Appeal of Planning Commission Resolution No. 26-02 Regarding Coastal Development Permit No. 21-045 and Variance No. 26-003 (24507 Vantage Point Terrace, APN 4458-033-006; Owner/Appellant, Meissner Family Trust)

Amended[1] Malibu City Council Special Meeting Agenda

Prepared by: Courtney Brown, Senior Planner

Subject: Appeal of Planning Commission Resolution No. 26-02 Regarding Coastal Development Permit No. 21-045 and Variance No. 26-003 (24507 Vantage Point Terrace, APN 4458-033-006; Owner/Appellant, Meissner Family Trust)

Proposed Location: Lower Building Pad

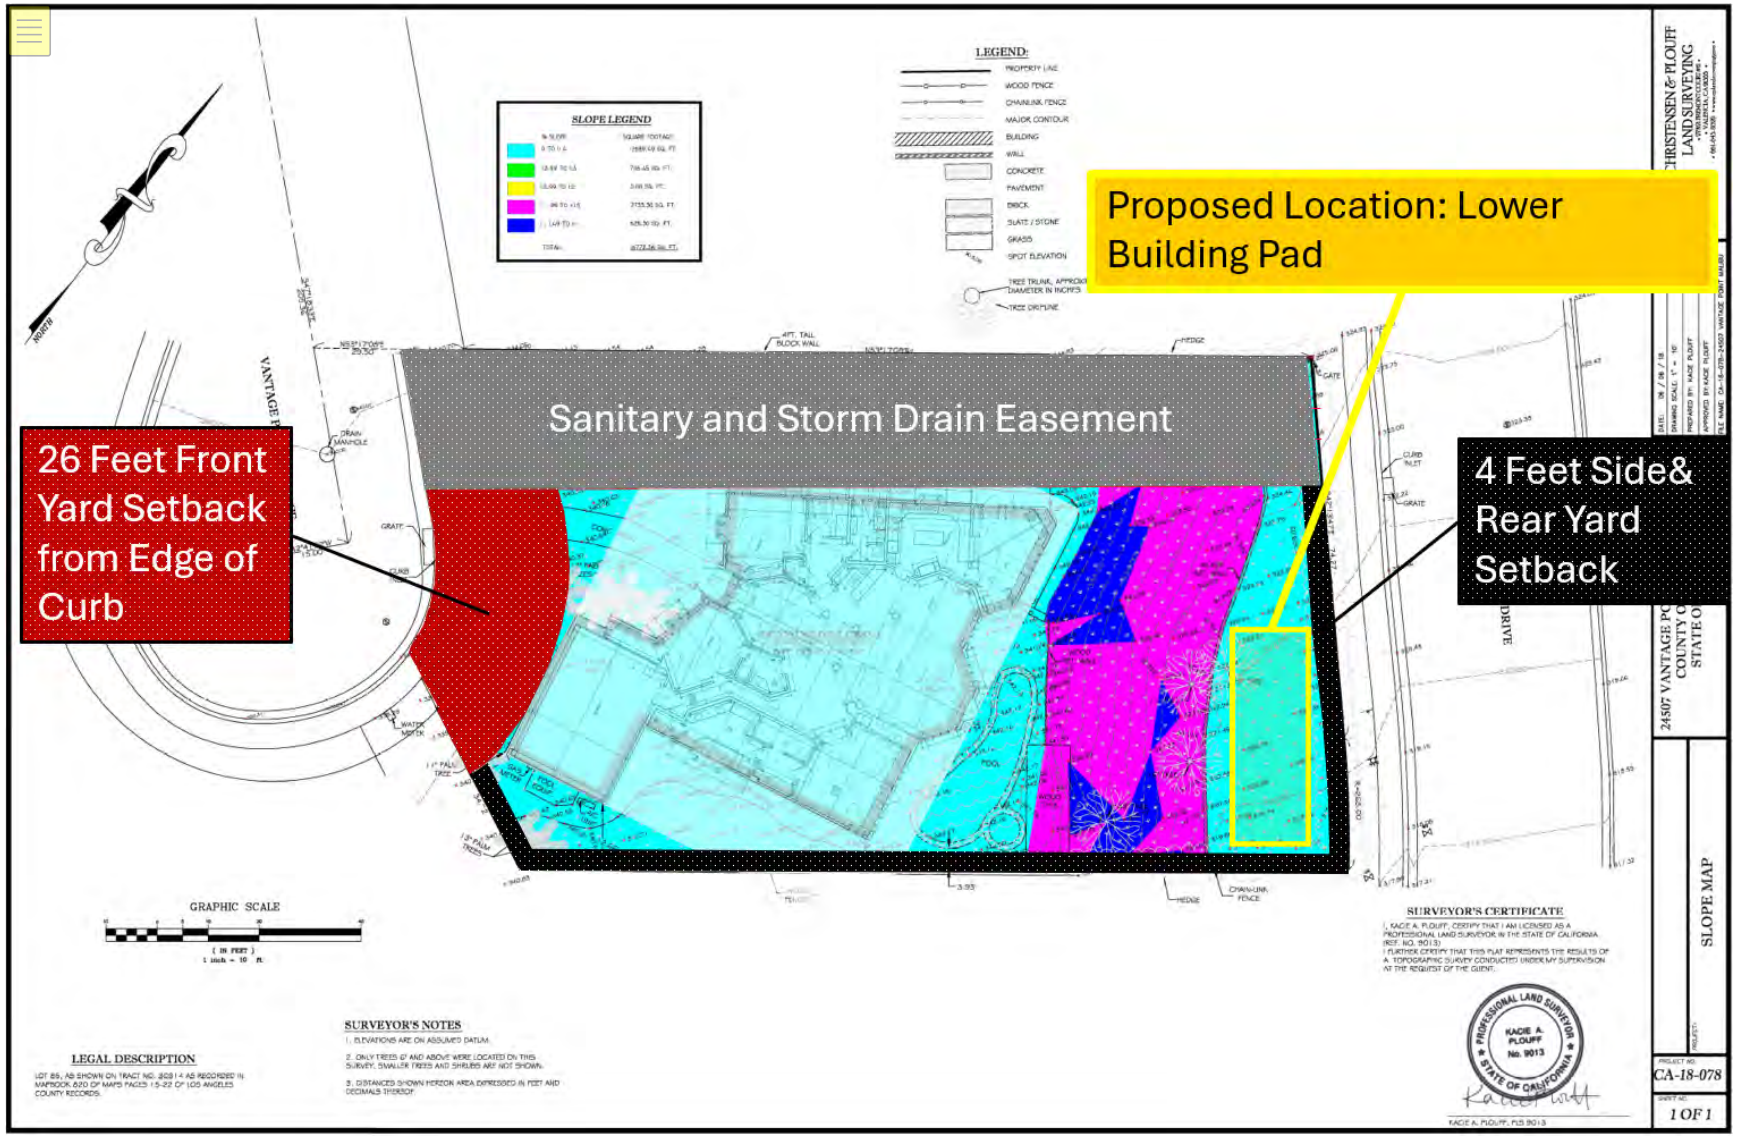
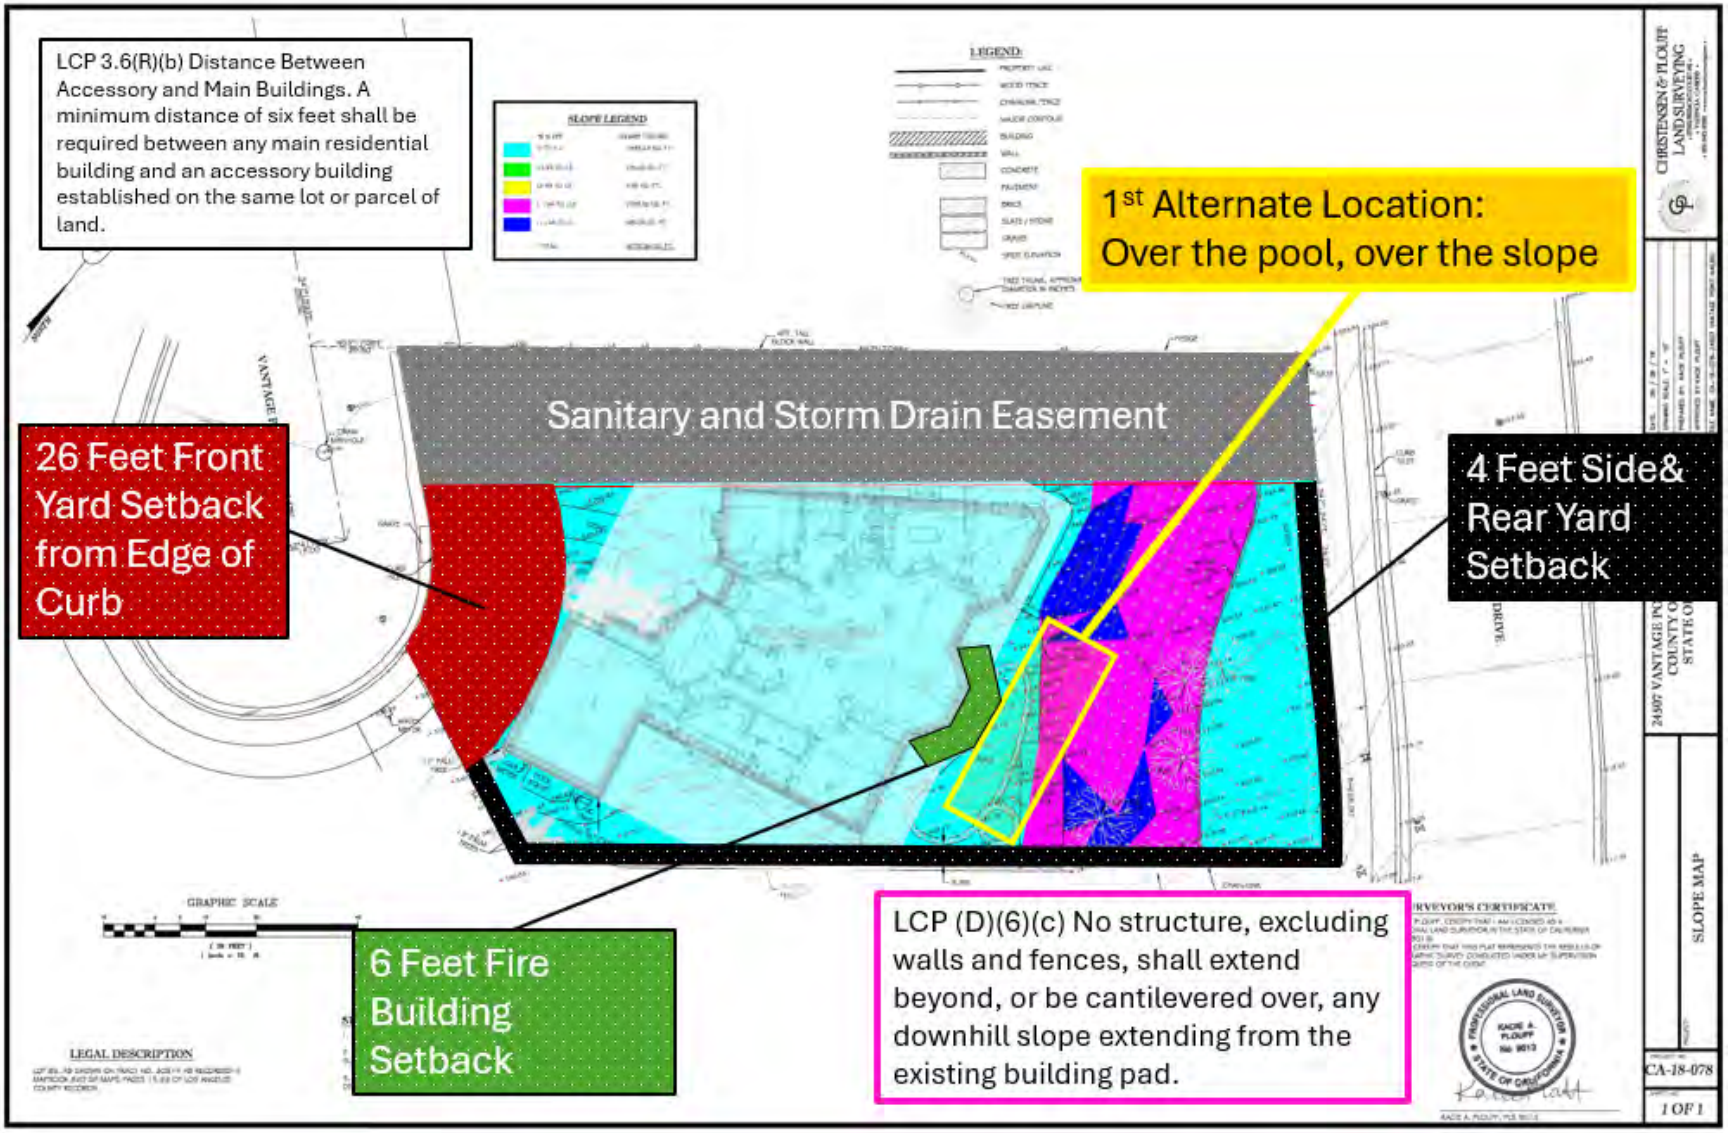
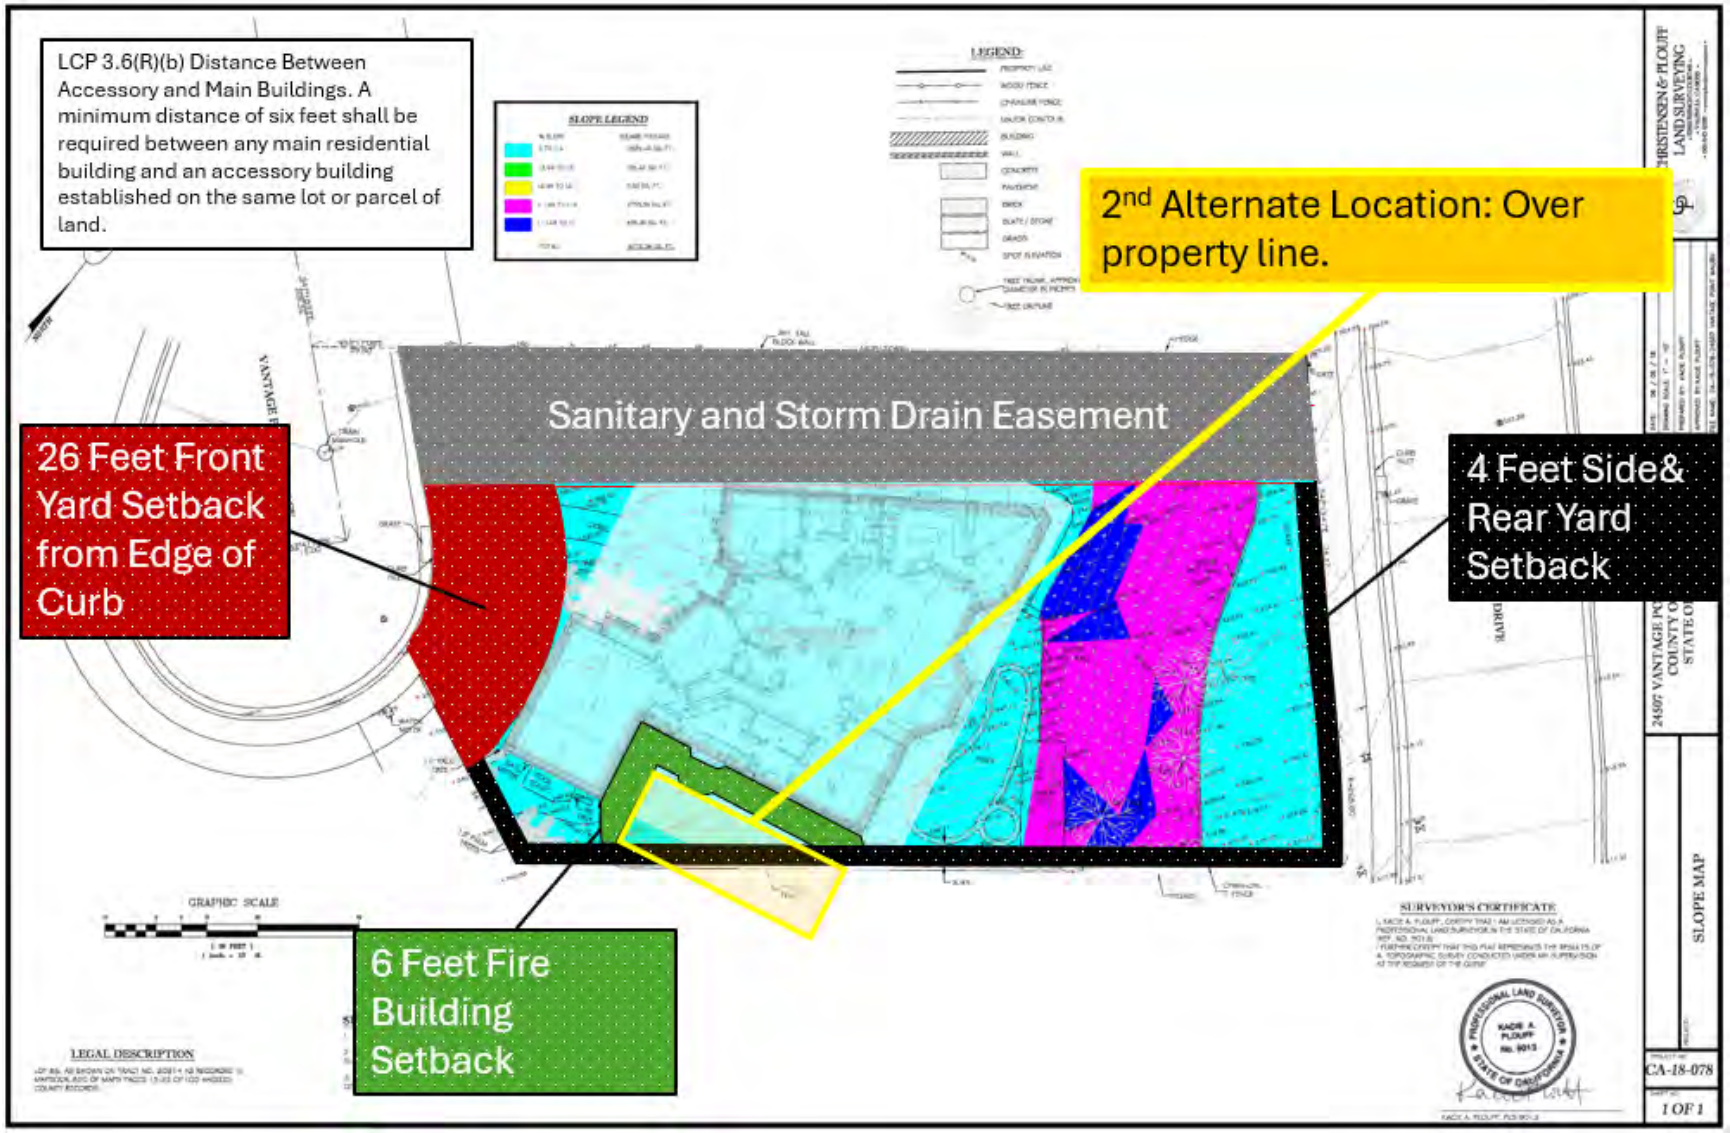
The rebuttal package also described two alternate locations for the ADU/Second Unit with justifications as to why each was considered by the applicant to be infeasible. Alternative 1 utilized the existing building pad and placed the ADU/Second Unit over the existing swimming pool and extension over the slope to the rear of the residence. The Planning Division concurred with the applicant that Alternative 1 is not feasible due to design constraints and additional development that would be required. Alternative 2 utilized the existing building pad and placed the ADU/Second Unit on the southeast side yard of the parcel near the southerly side of the residence and behind the three-car garage. The applicant states that the location is not feasible because it does not accommodate a prefabricated structure. Staff found that even if a prefabricated structure would be too difficult to place in that location, a different type of ADU appears feasible to be constructed in that area. Other alternatives not considered by the applicant, but which appear to be feasible, include converting part of the existing residence and/or garage, with or without adding square footage or building an addition to the single-family residence elsewhere on the lot in flatter areas with less existing development. These alternatives would ensure an ADU is constructed on the existing building pad consistent with the MCE Overlay standards. The Planning Division encouraged the applicant to consider one of these alternatives so that the proposed ADU could meet all of the LCP required development

standards; however, the applicant declined. Planning Division staff has reiterated that an ADU is feasible on the subject parcel and would be in support of an ADU in a compliant location; however, the applicant continues to desire the ADU/Second Unit be located in an area prohibited by the LCP and MMC.

Figure 1

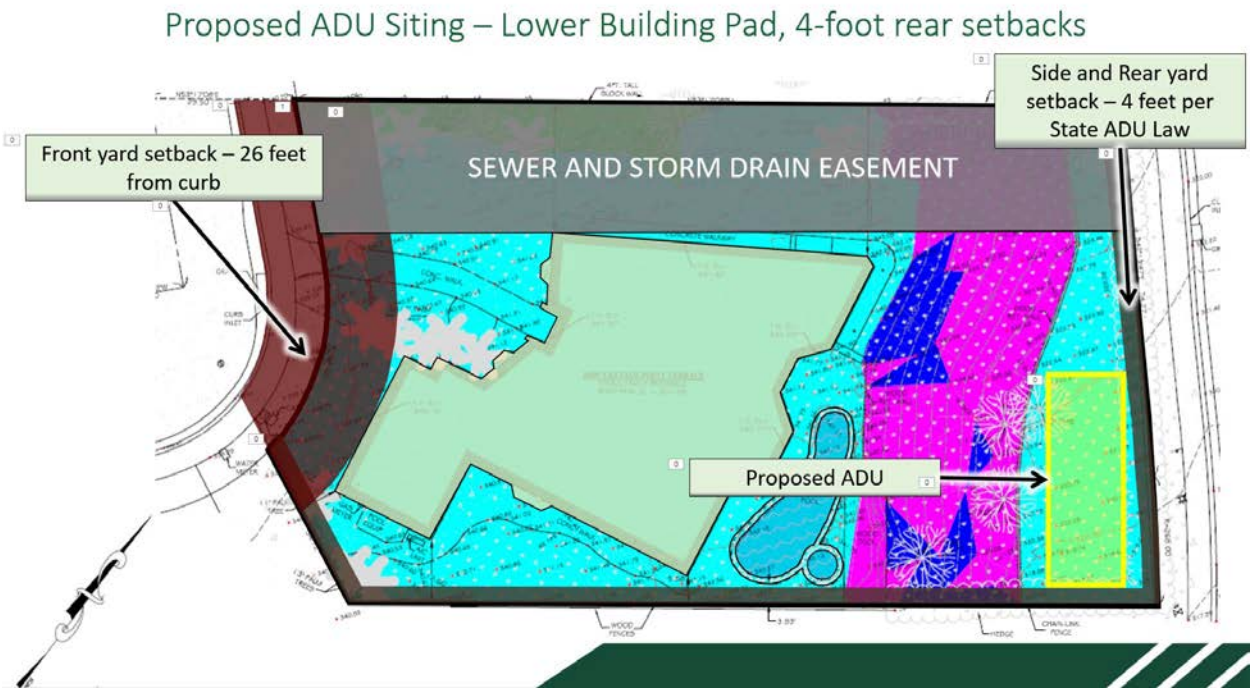
Figure 1 below shows the proposed ADU siting with variances for setback and second building pad, allowing siting fully on the lower building pad. Figure 2 shows the infeasibility of siting the ADU on the lower building pad without rear yard setback relief.
